Section 6 comments from Ballot on Draft Standard D2 (Vic Hayes, Chair, AT&T WCND)

Figure 6-10: RTS/CTS with Fragmented MSDU

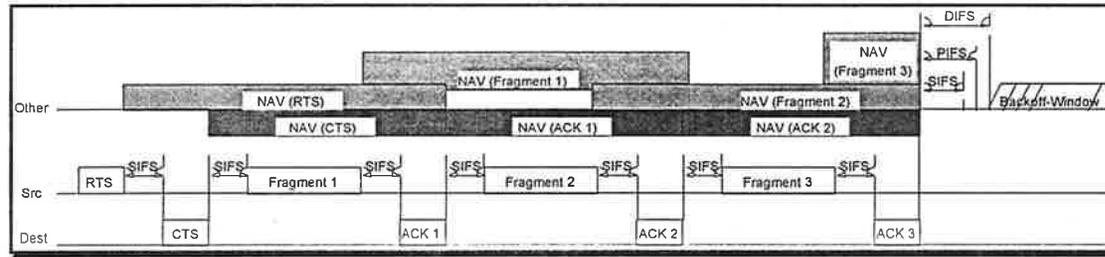
175	6.2.6.6	BTh	E		add box around RTS in Src line of Figure 6-10	All other frames have a box.	
176	6.2.6.6	ws	e		"warrents"	spelling	
177	6.2.6.6	DW	E		Figure 6-10 should be updated to correctly show the NAV as is caused by the Duration field in the data frame (from the end of the last fragment till the end of the Ack following the next fragment.		
178	6.2.6.6	HC	T	N	The following is a description of using RTS/CTS for the first fragment of a fragmented MSDU. RTS/CTS will also be used for retransmitted fragments if their size warrants it. The RTS/CTS frames define the duration of the first frame and acknowledgment. The duration field in the data frames define the duration to the end of the acknowledgement. and The duration field in the acknowledgment frames specifies the total duration of	The way it is: STA hears data fragment, sets NAV for duration of ACK, plus the DATA/ACK of next fragment. A lot of time wasted if the ACK lost. If DATA fragment duration had duration only up to the end of its ACK, STAs hearing it begin DIF/backoff	Reject - it is designed this way to mimic the RTS/CTS situation. The data and ack contain duration to lock out stations in their vicinity for the duration of the data.

Seq. #	Section number	your initials	Comment type E, e, T, t	Part of NO vote	Corrected Text/Comment	Rationale	Disposition/Rebuttal
179	6.2.6.6	HC	T	N	One of two things is required here. Either (1) hitting a dwell boundary needs to clear everyone's NAV, or (2) when DATA fragment and Ack are sent, STAs must calculate whether the next fragment/ACK are going to fit into the dwell, and not set their durations to include them if they aren't going to fit.	Following a dwell boundary STA's NAVs could come clear at some very screwy places. The source and destination STA of a fragment/ACK exchange just before the boundary are the only STAs with clear NAVs, and get a lot of priority access.	Reject - action at dwell boundary is unspecified. The implementation may tx over the boundary or calculate whether or not the transmit will fit.
180	6.2.6.6	BA	T	N	See section 6.2.6.6 attachment below	In the previous letter ballot, my recommendation of redefining the duration field was adopted, see doc 95/69. However, the change was never made to the D2 text. I am including my proposed text and updated figures as an attachment.

6.2.6.6 RTS/CTS Usage with Fragmentation

Each frame contains information that defines the duration of the next transmission. The RTS will update the NAV to indicate busy until the end of ACK 1. The CTS will also update the NAV to indicate busy until the end of ACK 1. Both Fragment 1 and ACK 1 will update the NAV, immediately after each frame is received, to indicate busy until the end of ACK 2. This is done by using the duration field in the DATA and ACK frames. This will continue until the last Fragment and ACK which will have the duration set to a SIFS+ACK time and Zero respectively. Each Fragment and ACK acts as a virtual RTS and CTS, therefore no RTS/CTS frame needs to be generated even though subsequent fragments are larger the aRTS_Threshold.
